INDESIT company

Model type:
BAAN33P

Commercial code:
F034704

n1025093: Doors / weather stripping combined fridges / freezers Indesit/2000 Melano and Setubal

N1030093fig1

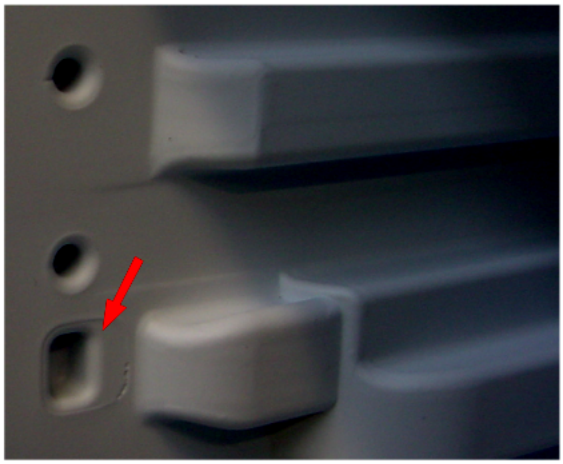
n1030093: New fixing of evaporator on static fridge-freezers (05 range) 60 cm,Melano

From August 05 (serial no. 50802.0001) the freezer evaporator is secured to the cabinet by a plastic profile.
The cabinet walls have been modified to create locations to house the profile, which is installed on the front of each evaporator plate (see photo N1030093fig1- fig2 - fig3)
The profile cannot be fitted on premodification appliances, so technical personnel must continue to fit the rh and lh supports on these models (see photo N1030093fig4)

New parts
C00141135 = WHITE PROFILE L=443.5 MM

Parts replaced
C00075596 = EVAPORATOR RH SUPPORT
C00075597 = EVAPORATOR LH SUPPORT

N1030093fig1

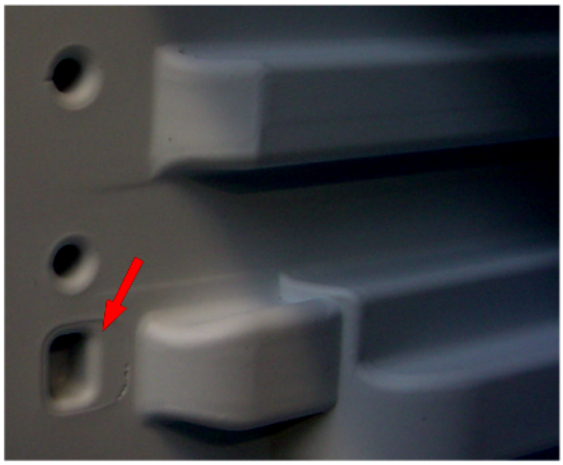
n1030094: New fixing of evaporator on static fridge-freezers (05 range) 60 cm, Lodowek

From August 05 (serial no. 50820.0001) the freezer evaporator is secured to the cabinet by a plastic profile.
The cabinet walls have been modified to create locations to house the profile, which is installed on the front of each evaporator

plate (see photo N1030093fig1- fig2 - fig3)
The profile cannot be fitted on premodification appliances, so technical personnel must continue to fit the rh and lh supports on these models (see photo N1030093fig4)

New parts
C00141135 = WHITE PROFILE L=443.5 MM

Parts replaced
C00075596 = EVAPORATOR RH SUPPORT
C00075597 = EVAPORATOR LH SUPPORT
